To: Plan Holders for the Pavement Maintenance Project at
Elko Regional Airport
Elko, Nevada
AIP Project No. 3-32-0005-050
PWP-EL-2019-169

**ADDENDUM NO. 3
 TO
 CONTRACT DOCUMENTS, SPECIFICATIONS AND PLANS
 FOR IMPROVEMENTS TO THE
 ELKO REGIONAL AIRPORT
 ELKO, NEVADA
 AIP PROJECT NO. 3-32-0005-050
 PWP-EL-2019-169**

PAVEMENT MARKINGS
RW 6-24 DETAIL

5 AIRFIELD COMPASS
N.T.S.

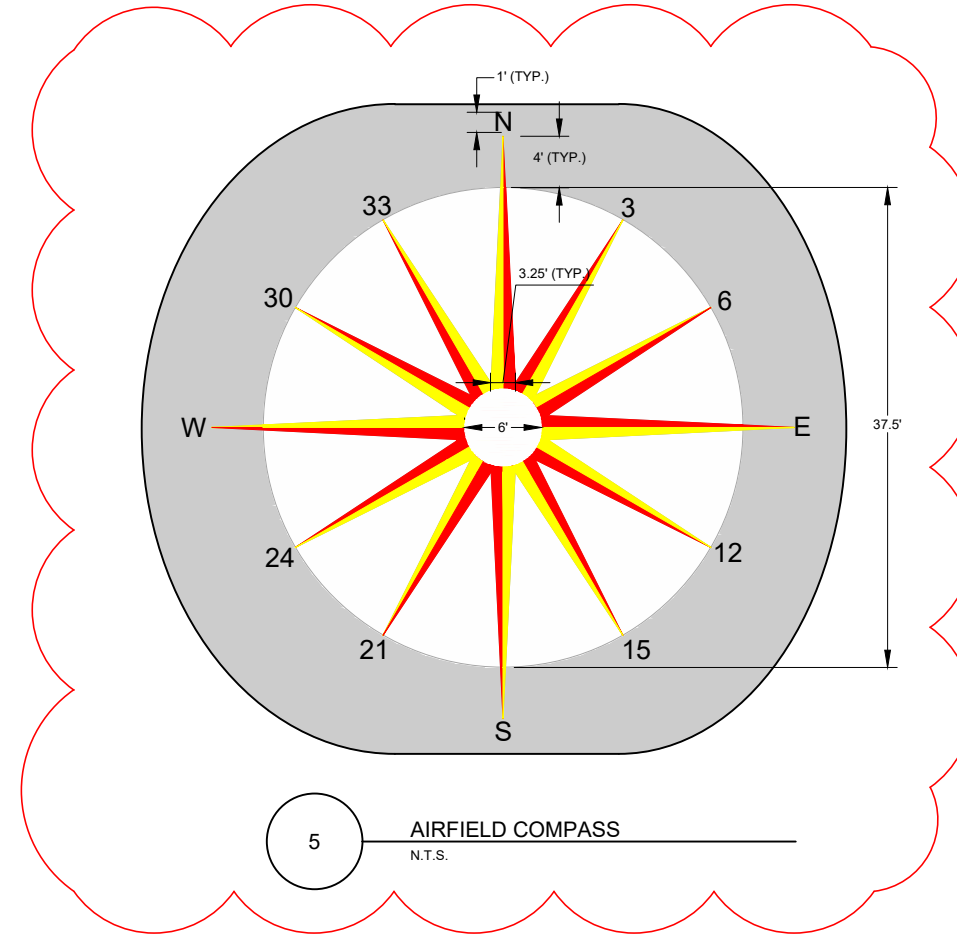
PLAN SHEET C750: Corrected compass detail to show inner circle as white. Added width dimension for all compass arms.

3. *On Plan Sheet 43 Detail 5, what are the colors of the Compass? What are dimensions of various elements of the Compass (e.g. Width of arms, size of numbers along the outside, Radius of the interior Circle)?*

Answer: The compass is Yellow, Red, and White and must comply with the P-620 Marking specification. See amended plan sheet C750 for the dimensions and colors of the compass.
